Addendum No. 1
100% Construction Documents

June 10, 2025

Project:
FSU Parking Garage 1 Remodeling

ALW Project No. 19370.42

2 Typical Bulkhead Detail
1 1/2" = 1'-0"

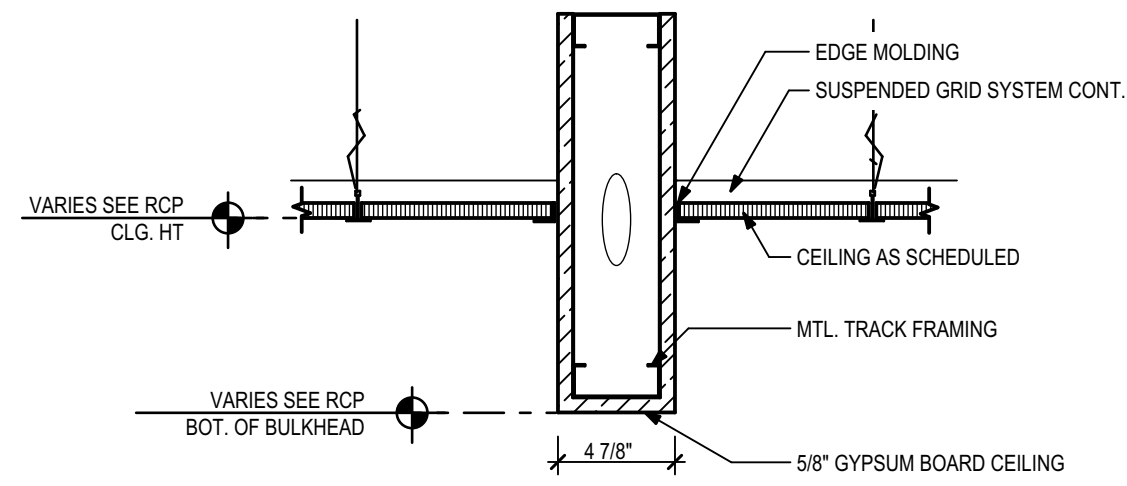
- **Revise** depth of the gypsum bulkhead in Lobby 5000.
